Subject: Magee Preserve
Danville, California

RESPONSE TO PUBLIC COMMENT

RELOCATED STORM DRAIN OUTFALL ANALYSIS

FIGURE NO.
1

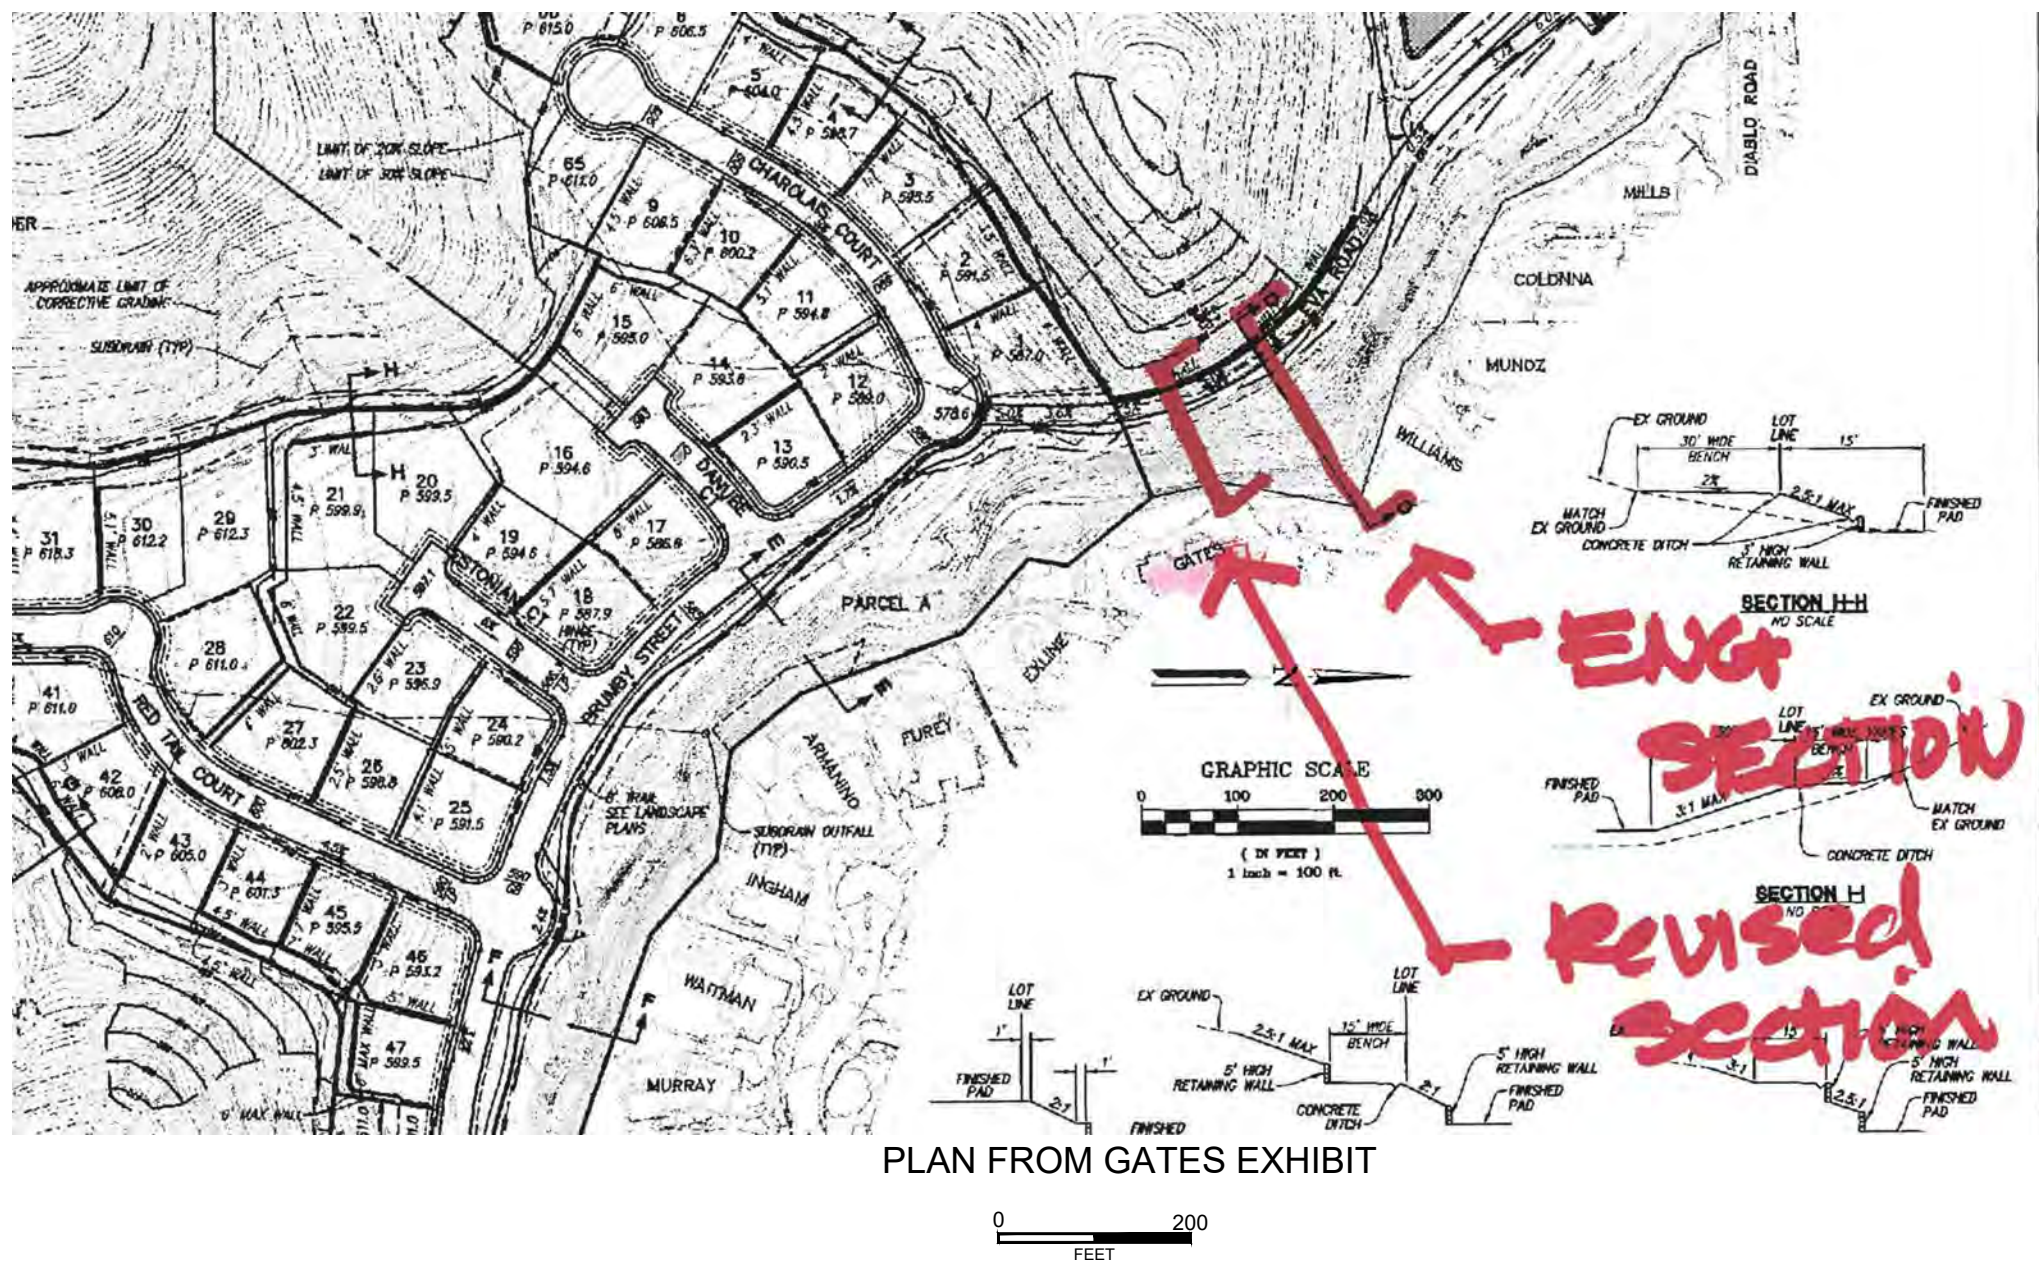
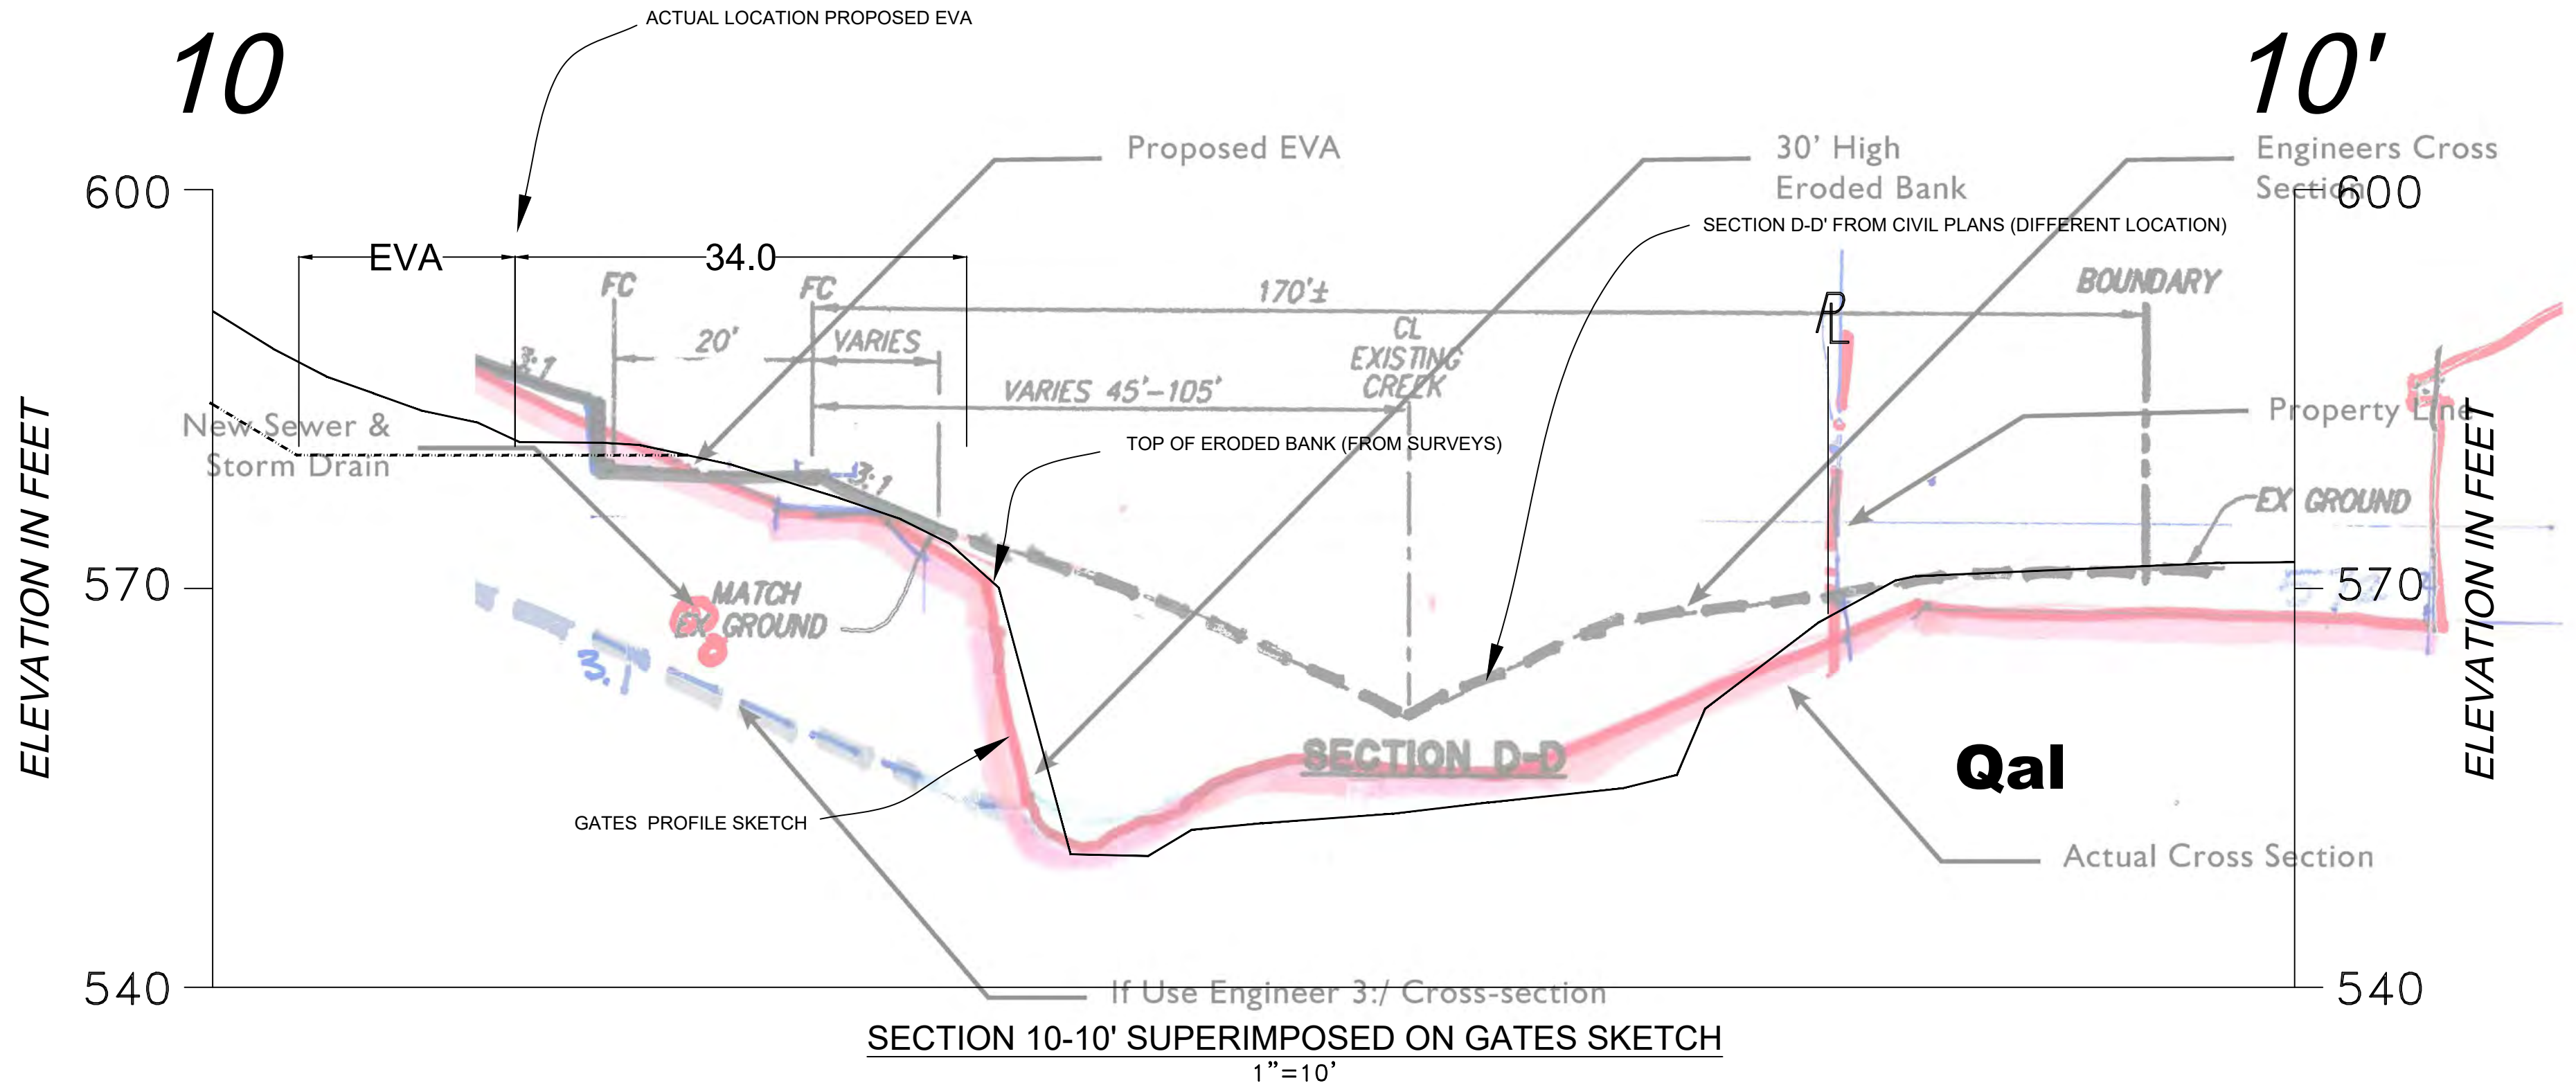
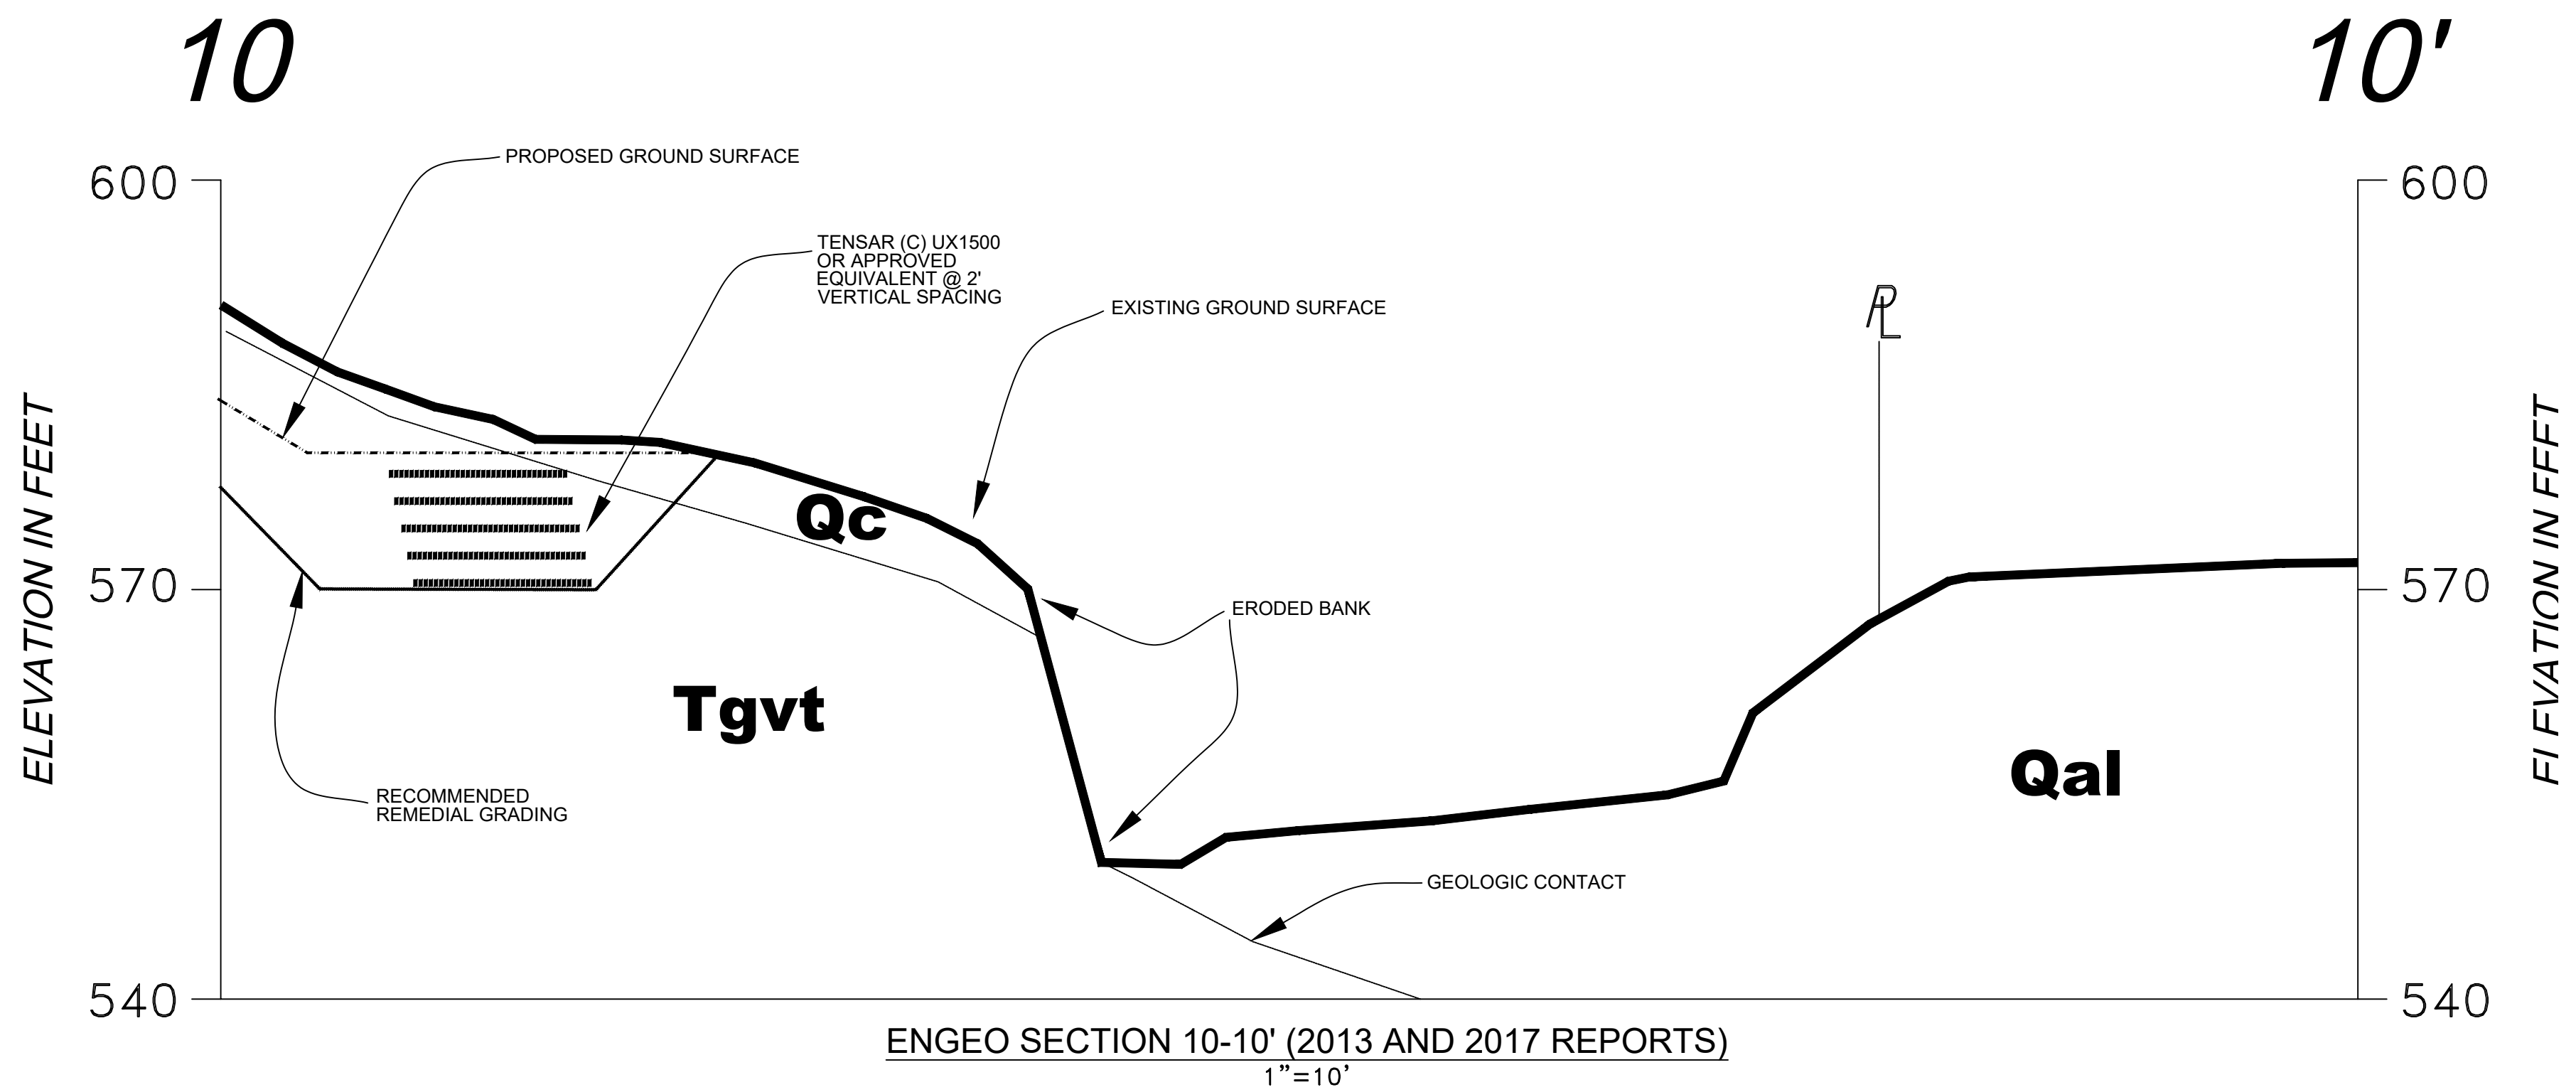
The proposed plans fail to accurately identify the modifications to the creek corridor required to construct the development. Cross-sections depict a creek at 3:1 slopes and no significant trees. In reality, the creek is deeply incised with numerous vertical banks and a dense canopy of mature trees lining the slopes. To construct the project (EVA Road and 4' storm inlet (Outfall)), will require the removal of a number of large oak trees, the construction of major retaining walls in the creek channel and thus, significant modification to creek hydrology.

On the second page of Reference 5, the Gates overlaid a diagrammatic cross section (Section D-D') from the 2017 grading plan on another cross section depicting the ground surface profile about 30 feet to the east (Referred to as "Actual Cross Section"). Because the Gates exhibit compares two completely different ground surface profiles, the overlay erroneously implies that the proposed EVA road grading will require filling on steep slopes directly over an existing steep creek bank and that an earth retention system will be required inside the creek banks. In fact, the Gates "Actual Cross Section" appears to be the same or similar to ENGEO Cross Section 10-10', (shown on attached Figure 1). Our Cross Section 10-10' includes the proposed geotechnical corrective grading, and the actual location and elevation of the proposed EVA road. As shown on our Cross Section 10-10', the proposed EVA road will be constructed in cut and will be located more than 30 feet from the top of the steep creek bank. The EVA road construction will not require retaining walls for support.

This comment points out that the topographic contours shown on the grading plans (Reference 6) do not fully depict incised creek conditions in the area north of the proposed EVA road. The incised creek conditions were recognized during project planning and documented by performing ground surveys in the creek channel in 2013 (recently updated in 2018) to obtain accurate representations of the creek bank morphology. The eroded area described in the Gates's letters was documented and discussed in the 2013 ENGEO report (Reference 1, Figure 6, and on Cross Section 10, Figure 5B). The design of corrective grading for the EVA road presented in References 1 and 2 recognizes the eroded creek bank condition and provides mitigation measures as described below.

The ENGEO geotechnical reports (References 1 and 2) provide recommendations for construction of a stable foundation for the EVA road. As shown on Cross Section 10-10', the proposed stabilization measures will include excavation of a 10-foot-deep, 25-foot-wide keyway, and replacement of geogrid-reinforced backfill. All of the proposed corrective grading will be constructed within the approximate limit of disturbance as shown on Figure 1 without the need for tree removal. Surveyed tree locations on the creek banks are depicted on the grading plans, as shown on Figure 1.

creek in this area. The storm drain ("utility") lines will be located under the EVA road and entirely within the disturbance envelope shown on Figure 1. There are no retaining walls proposed on the creek banks or in the creek channel.
